Submissions and Amendment Report – SSD 15822622

Ivanhoe Estate, Macquarie Park
Stage 2 'Midtown' State Significant Development
Application

Submitted to Department of Planning and
Environment

25 March 2022 | 17156

Figure 3 Proposed changes to the social housing lobby line of sight

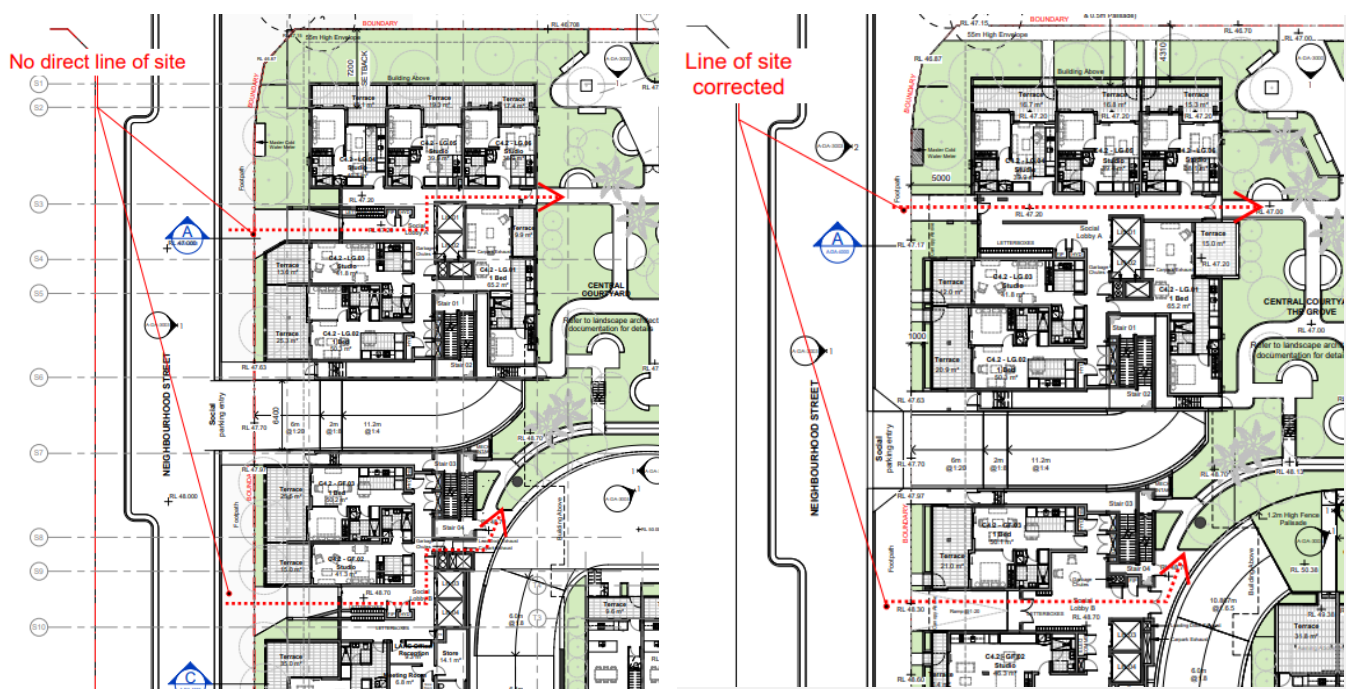
- Rearrangement of social lobby to provide a clear and generous physical and visual link between the central courtyard ('The Grove') and the street in response to the SDRP comments.

Figure 5 Overlay of the approved Building A1 and proposed Building C4

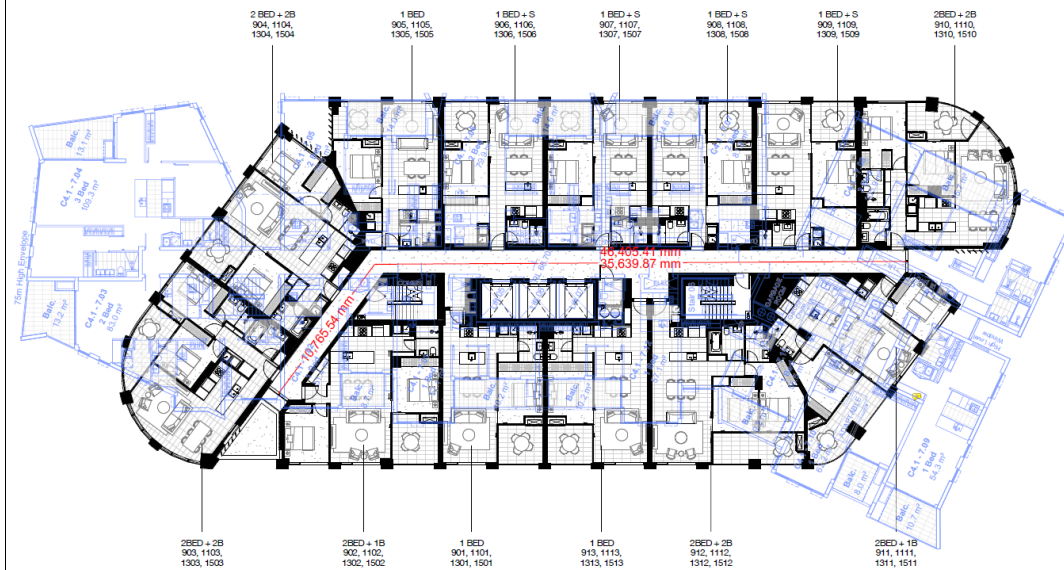
Issue Raised	Applicant Response
Future Residential Amenity	
<p>Implement measures to ensure suitable privacy and amenity is provided between dwellings located in the social and market elements of Building C4 above level 8, noting the proposed building separation distances at the north-eastern end do not fully satisfy the recommended ADG building separation distance of 24 m.</p>	<p>Privacy screens have been added to Unit C4.1 - 8.01 as well as units in this location on upper levels (i.e. Level 8 to Level 16) to mitigate privacy concerns in accordance with the ADG design guidance for visual privacy. Apartments have been designed with view directors ensuring there is no overlooking between apartments. Refer to updated Architectural Plans prepared by Cox Architecture (Appendix D).</p>
<p>Provide further justification for the provision of less than 70% of dwellings in Building C4 receiving a minimum of two hours solar access in midwinter between 9 am and 3 pm.</p>	<p>The proposed Stage 2 buildings remain consistent with the Concept Masterplan (SSD-8707) approval that has been obtained for sitewide compliance, rather than individual building compliance. The assessment of the Masterplan determined that while the Block C4 buildings would not achieve the numeric control, Building C3 would exceed this amenity criteria. This detailed design phase of the project, therefore, remains consistent with the Concept Masterplan that recognised some individual buildings within the Masterplan will not achieve 70% solar access but that Midtown will provide an appropriate degree of solar access and amenity at a precinct scale.</p> <p>A key reason for the numerical non-compliance for Block C4 is the comparatively higher number of 3 bedroom units being provided as part of Stage 2 Midtown, contributing to housing choice and providing more opportunities for families to form part of the developing Midtown Estate. Numerical compliance could be achieved if the northern building facades were revised to include a high proportion of one bedroom and studio units, however, this would not achieve the same social benefits or provide a housing typology that is currently underrepresented in the market.</p>

It is also noted that the approved Building A1 within the Ivanhoe Estate has a commensurate arrangement of 12 units per floor (on average) that are accessed from a 45m long corridor (see below comparison). Frasers Property Australia has successfully delivered other buildings of this scale and arrangement as detailed in the table below.

Building	No. of units to floorplate	No. of lifts	No. units per lift per floor
Midtown C4	12	3	4
Midtown A1	12	3	4
Central Park Block 5C	20	5	4
Central Park Block 5B	14	3	4.7
Central Park East Tower	17	5	3.4
Central Park Connor	21	3	7
